ERRATA

Technical Manual ME-1653

Distribution Amplifier Model 203-3

Req. Source: EC 2276-404B/G/J

SIZE	203-3-101
B	
	SHEET

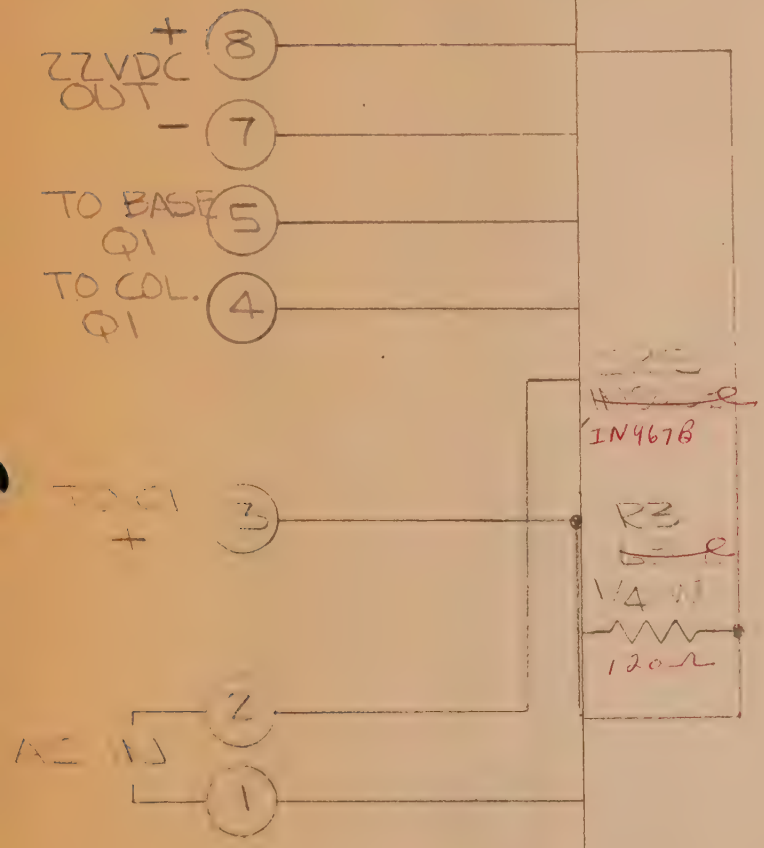
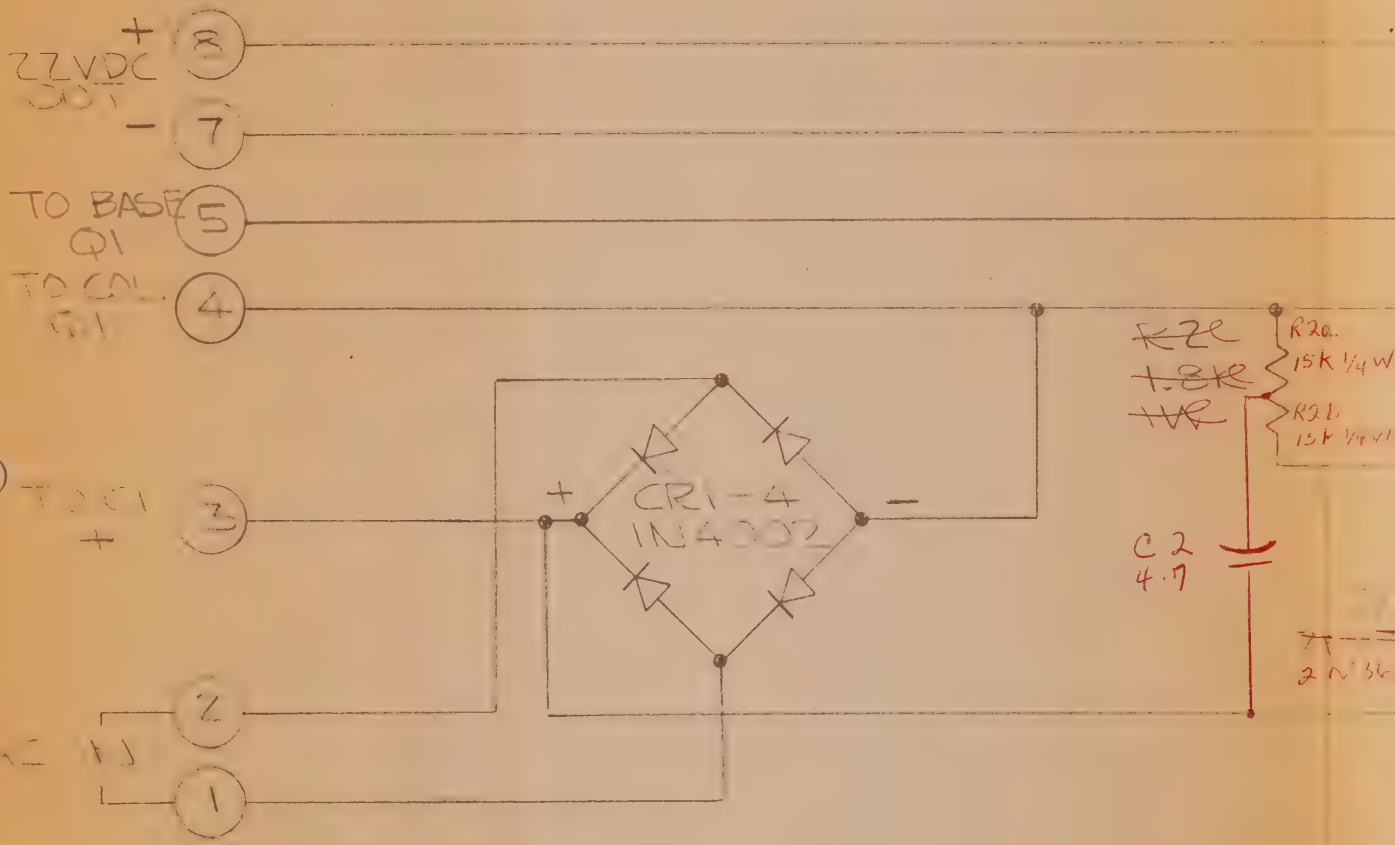
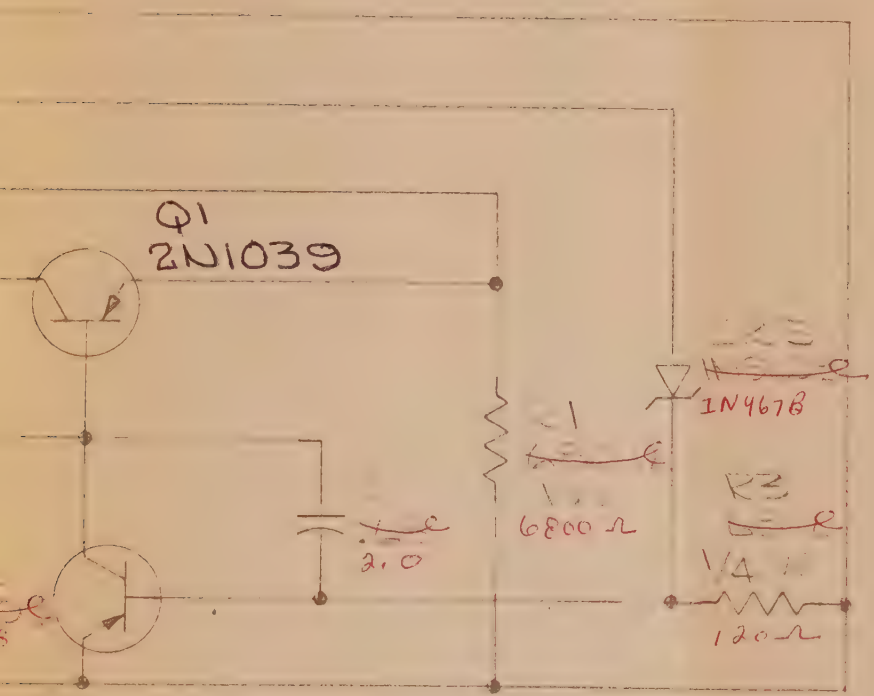
2. Page 4-2, para 4-4. Add: "Any transient voltages are coupled to the base of amplifier Q1 (via C2 and R2b) to vary the bias (hence, output) which, in turn, varies the resistance of series regulator transistor Q1 (on the chassis) to suppress the output trancients."

4. Page 6-4.

a. Delete all entries for C1, and above the deleted entries, add: "C1," "Capacitor, fixed ceramic, 2.0ufd, 50V ±10%," "20-0003," and "Aerovox."

b. Above "CR1 through 4" entry, add: "C2," "Capacitor, 4.7ufd, 35V," "56289," and "Sprague."

c. For R1 Description, change "1 W" to "1/2 W," and "680 ohms" to "6800 ohms"; change Type to "RC20GF682J"; change Manufacturer to "MIL-STD."

d. Change "R2" to "R2a, R2b," change "1 W" to "1/4 W" and "1.8K" to "15K," change "GB1825" to "RC12GF153J," and "Allen-Bradley" to "MIL-STD."

e. For R3, change "68" to "120," change "147918" to "R12GF121J," and "Montronics" to "MIL-STD."

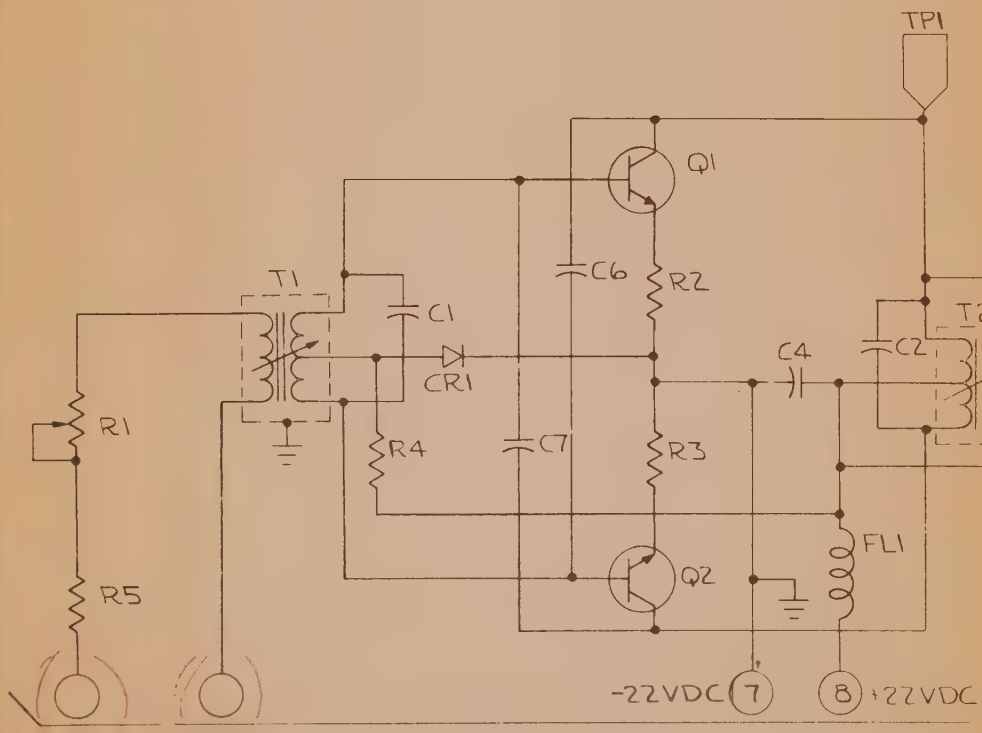
7. Drawing 203-3-105/106/107, 5mc, 1mc, .1mc Amplifiers. In the 203-3-105 column:

a. For C4 change ".05UF" to "2.0UF."

b. For R4, change "68K" to "15K."

5MC, 1MC, .1MC
PRE-AMPLIFIER

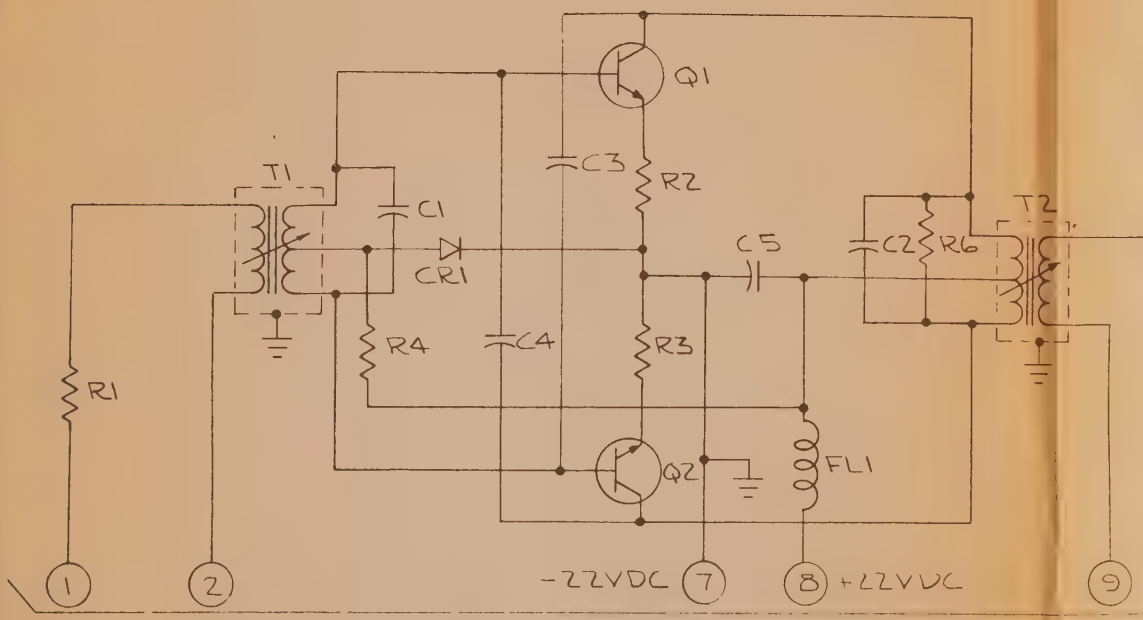
6. Drawing 203-3-102/103/104, 5mc, 1mc, .1mc Pre-amplifier. In the 203-3-104 column of the parts table, for CR1, change "1N483B" to "1N3728."

CHASSIS WIRING DIAGRAM

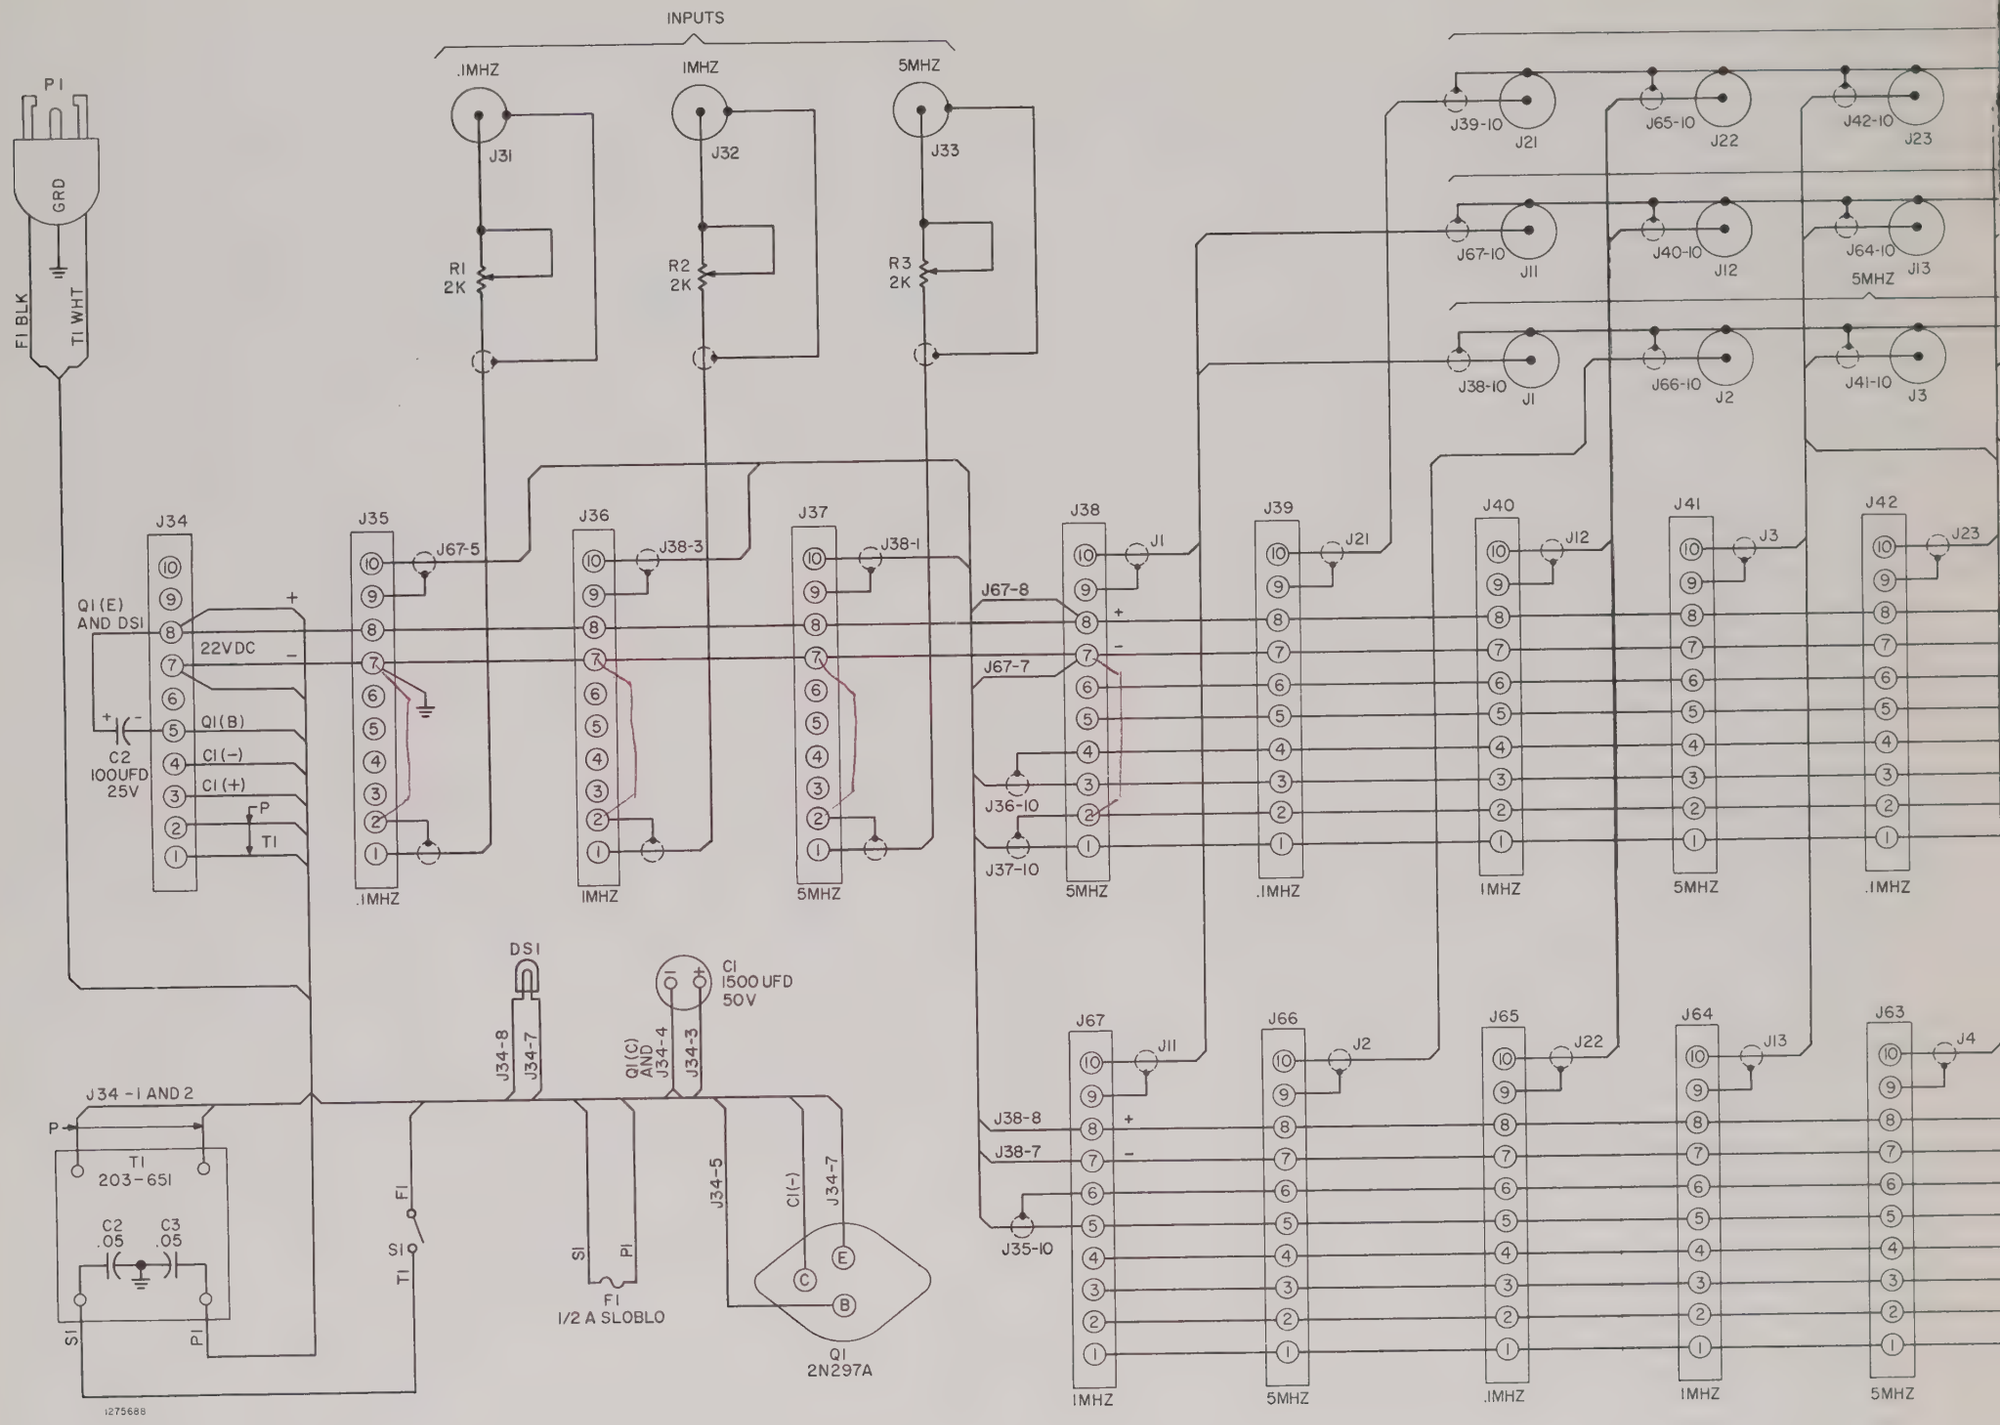
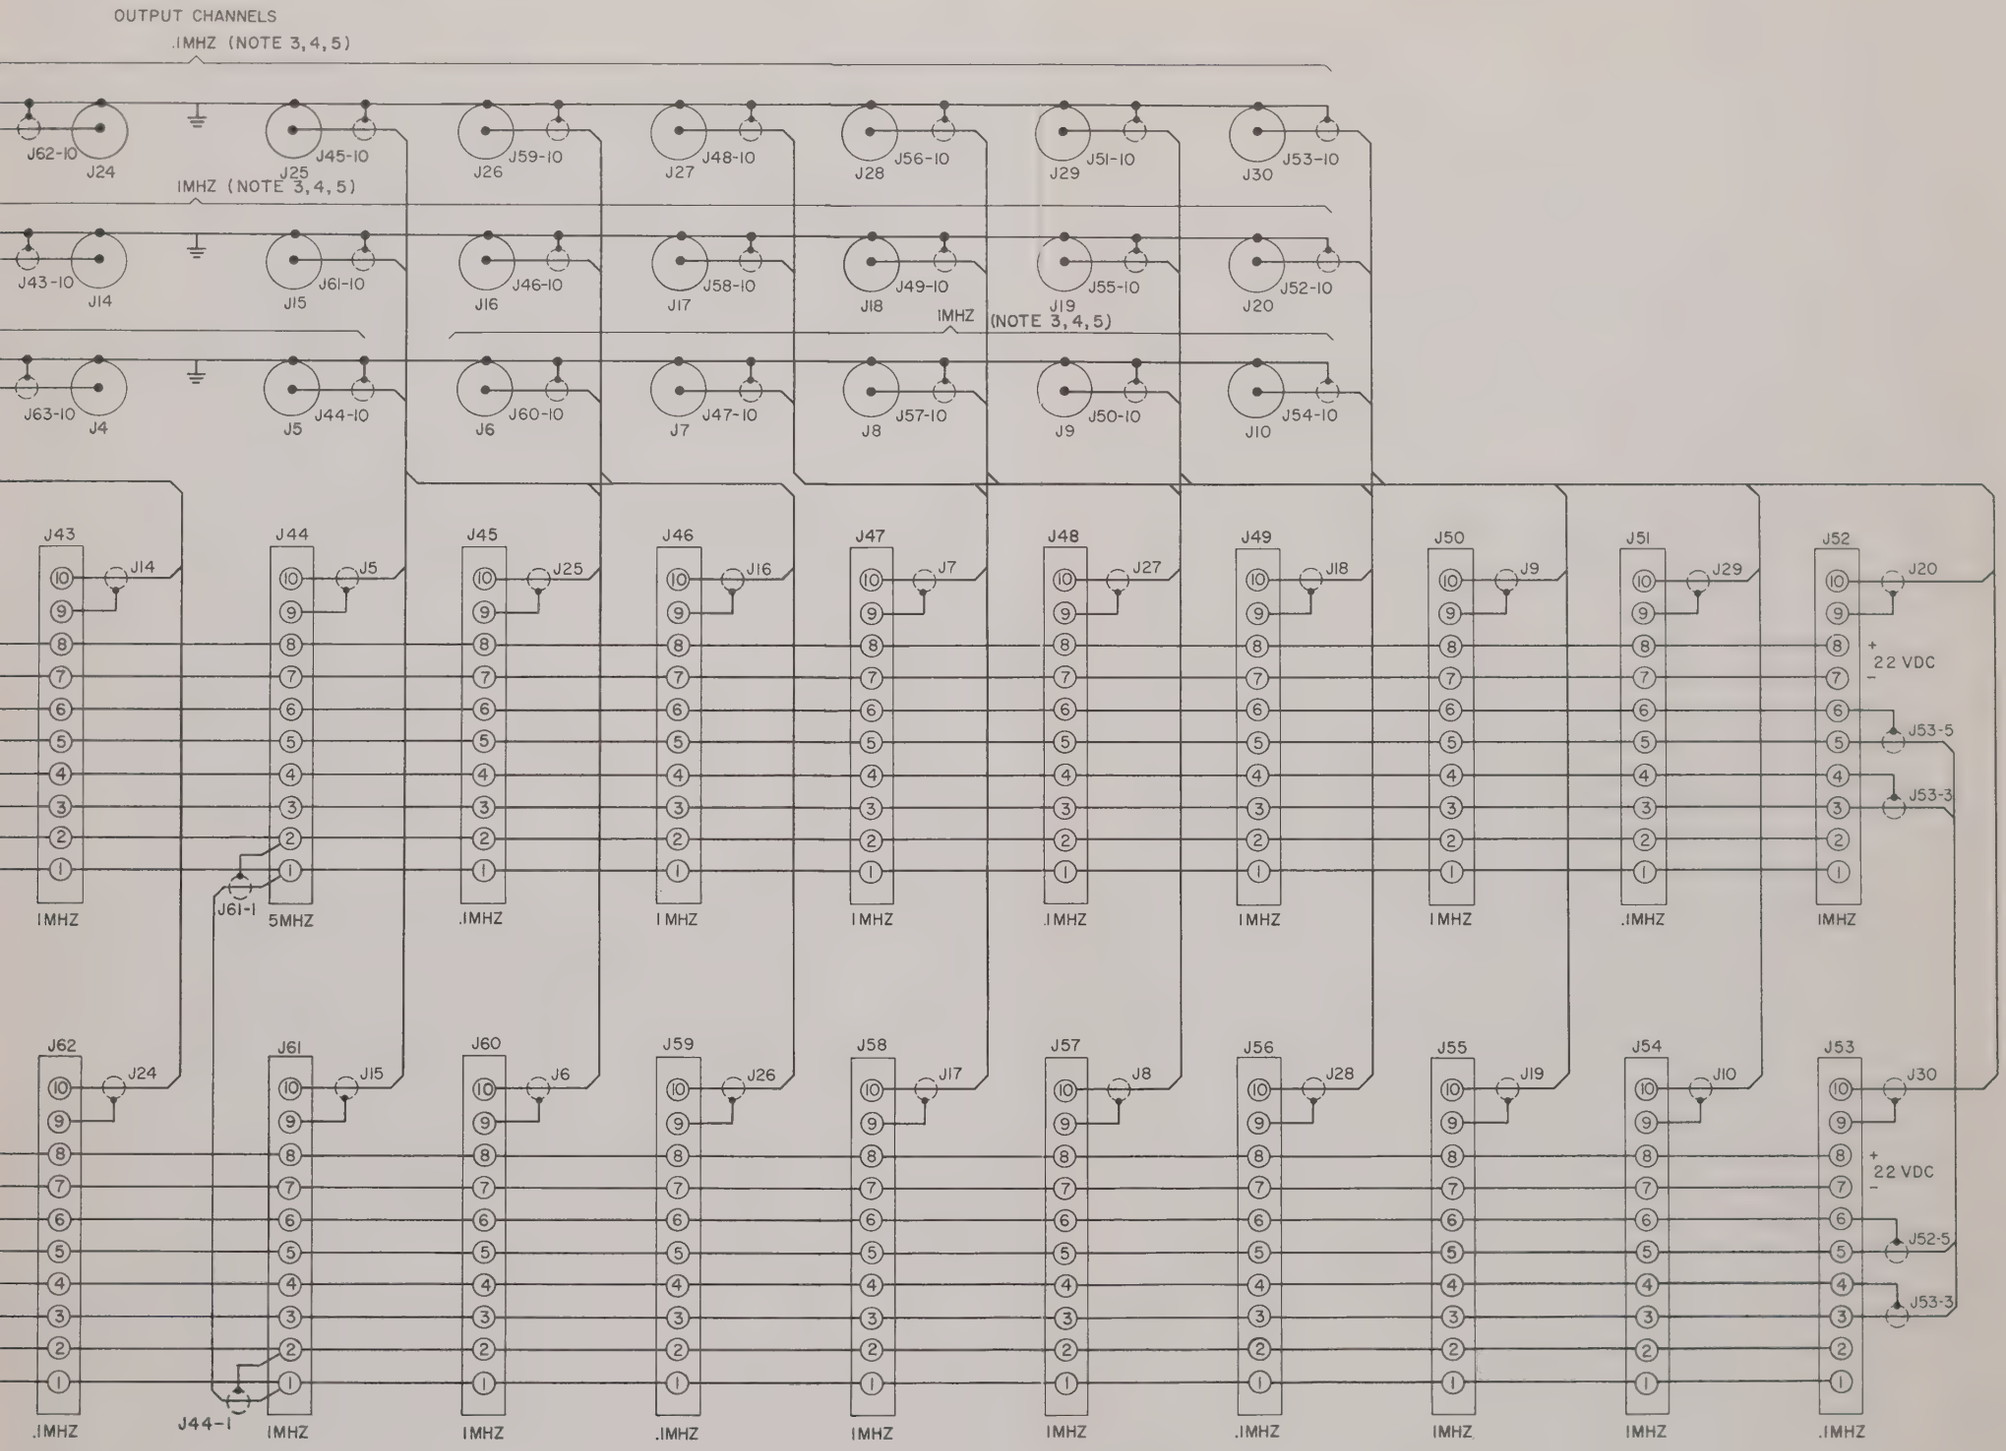
8. CHASSIS WIRING DIAGRAM.

a. R1, R2, R3. Change "2K" to "50Ω."

b. J35, J36, J37, J38. Draw a line connecting J35 pin 2 to J35 pin 7; connect pin 2 to pin 7 in a similar manner on J36, J37, and J38.
